RE: AURORA FOOD STORE
2000 ANAQUOD ROAD
REGINA, SK
Commission No. 2445

RE: Baler, Compactor & Power Pack (Fixture Plan R04)

Project: Aurora Grocery Store
2000 Anaquod Road, Regina, Saskatchewan
Subject: Receiving 190 Equipment Revisions
Date: 2025.08.11

Subject: Receiving 190 Equipment Revisions
References: Electrical Drawing E2.0 – Floor Plan - Power

SHEET TITLE:
FLOOR PLAN - POWER
COMMISSION NUMBER:
2445
SHEET NUMBER:
E2.0

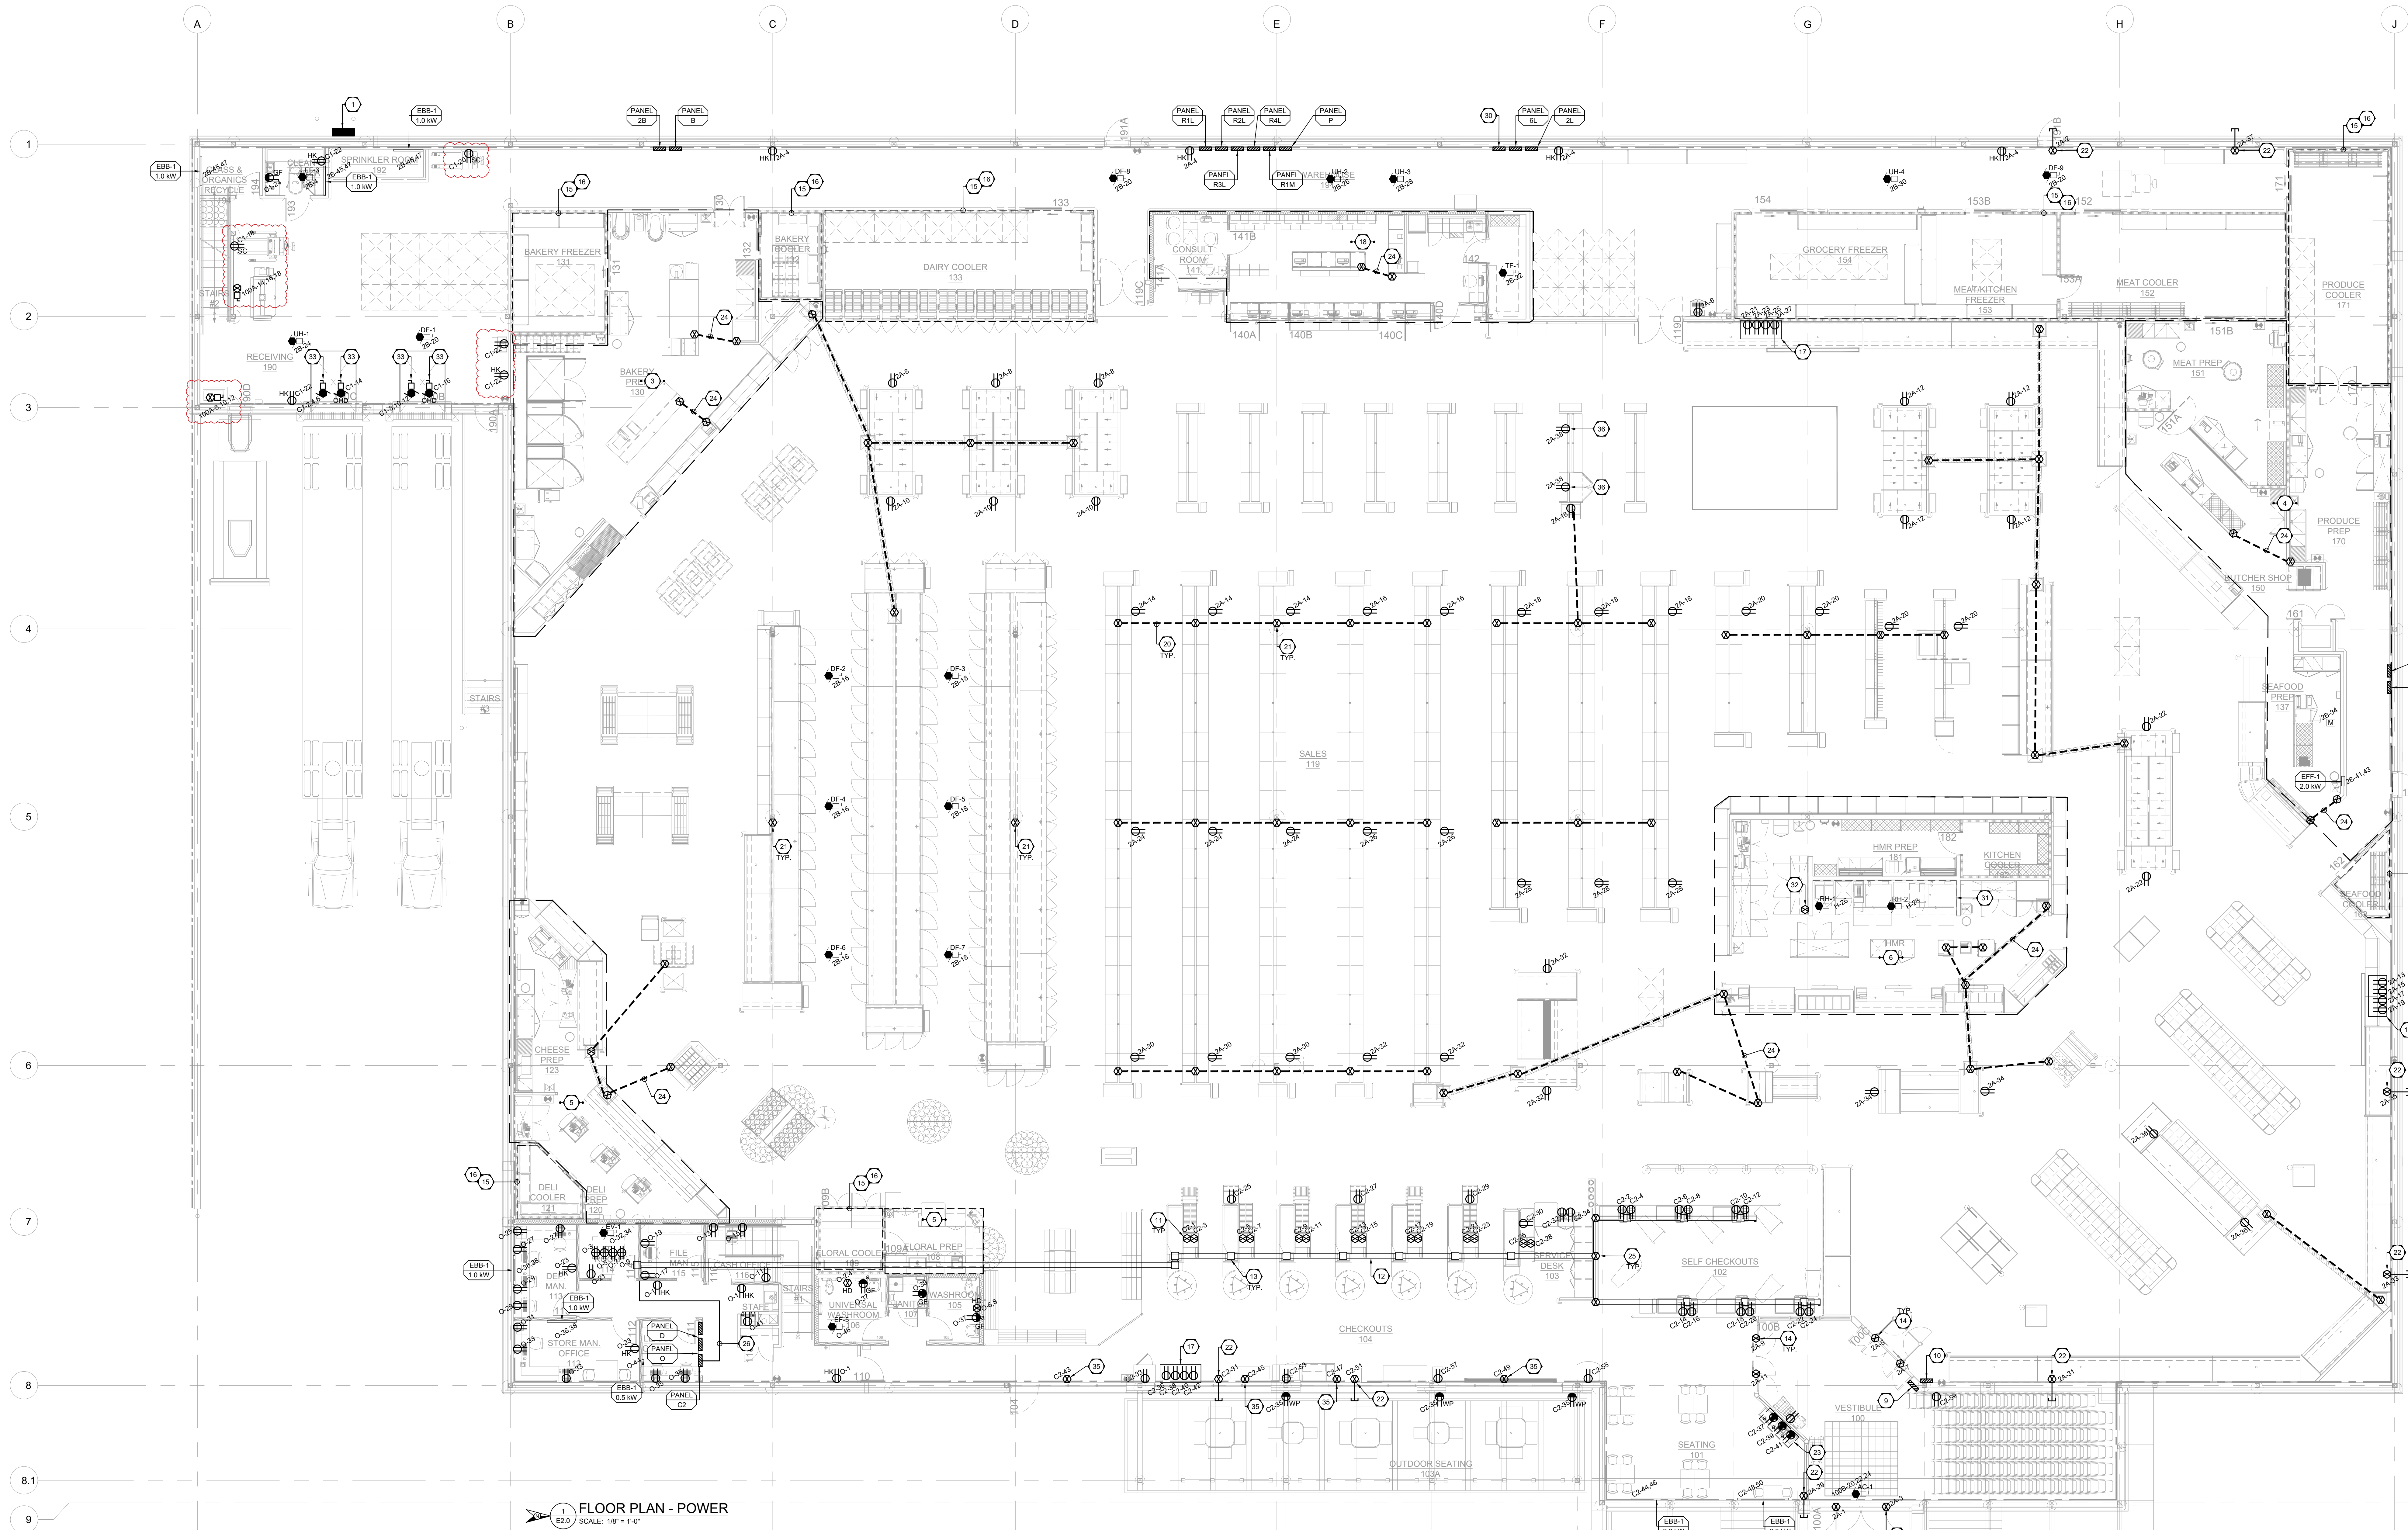
1. Refer to attached drawing E2.0 for the relocation of the following equipment.
 - 1.1. Compactor within 'Receiving 190'.
 - 1.2. Baler within 'Receiving 190'.
 - 1.3. Two(2) power jack charger receptacles within 'Receiving 190'.
2. Provide one(1) receptacle for power and one(1) data outlet to the CAO receiving desk within 'Receiving 190'. Wire and connect receptacle to circuit 'C1-22'.
 - 2.1. One(1) housekeeping receptacle is shifted ~7' to make room for the CAO receiving desk. Refer to attached drawing E2.0.
